Planning and regulatory committee

Wednesday 10 October 2018

49. 181583 - LAND FRONTING STATION APPROACH (CITY LINK ROAD), HEREFORD

182314 - SUMMARY DESCRIPTION (FOR FULL DESCRIPTION SEE APPLICATION FORM AND PLANNING CASE STATEMENT): • PROPOSED NEW FIELD ACCESSES • PROPOSED MAINTENANCE TRACKS TO SERVE SOUTHERN LINK ROAD (APPLICATION 151314) AT MULTIPLE PARCELS OF AGRICULTURAL LAND, SOUTHERN LINK ROAD CORRIDOR (151314) A465 - A49, HEREFORDSHIRE

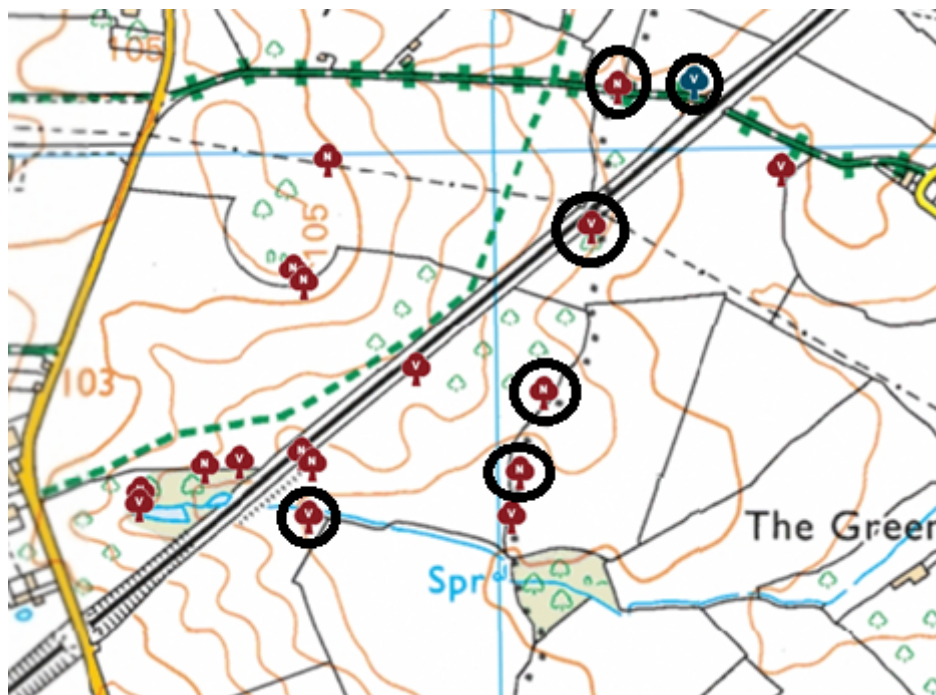
These trees can be identified on the Ancient Tree Inventory via the links I have included above. If mapped against the proposed plans these trees can be identified, I have circled them below for you.

In summary, we maintain that the trees in question are veteran specimens and should be treated as such, including being afforded a buffer 15 times their diameter in line with NE's Standing Advice. We also consider that any new development, whether cycle routes or haul routes, should not be located within the RPAs of veteran trees as this would result in temporary damage to these trees and that every possible measure should be explored to ensure avoidance.

OFFICER COMMENTS

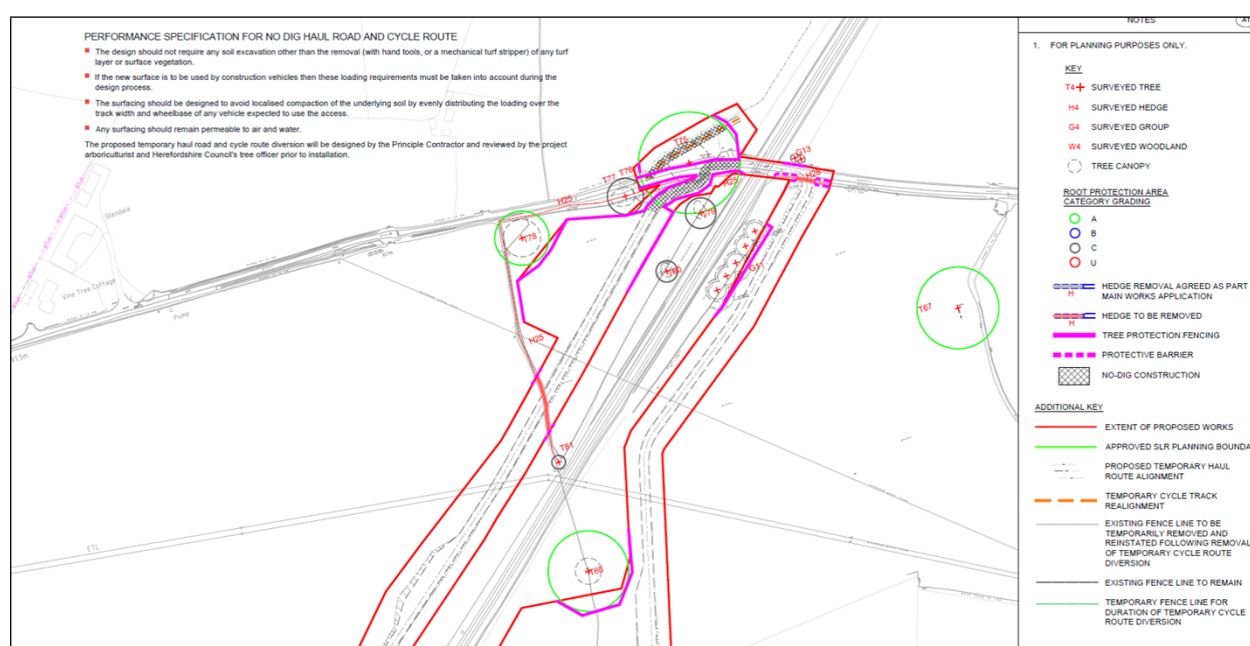
As members will see from the above correspondence, the Woodland Trust has raised concern about the assessment and impact on a number of trees affected by the temporary Haul route and temporary cycle route.

Central to this issue is whether the trees are, in fact, veteran trees.

Prior to commencement of any development detailed on drawing number – 3512983BP-WSP-ZO-XX-DR-T-00003-P04 Sheet 3 - a detailed Tree Protection and Mitigation plan shall be submitted to and approved in writing by the Local Planning Authority that shall include, but not be restricted to:
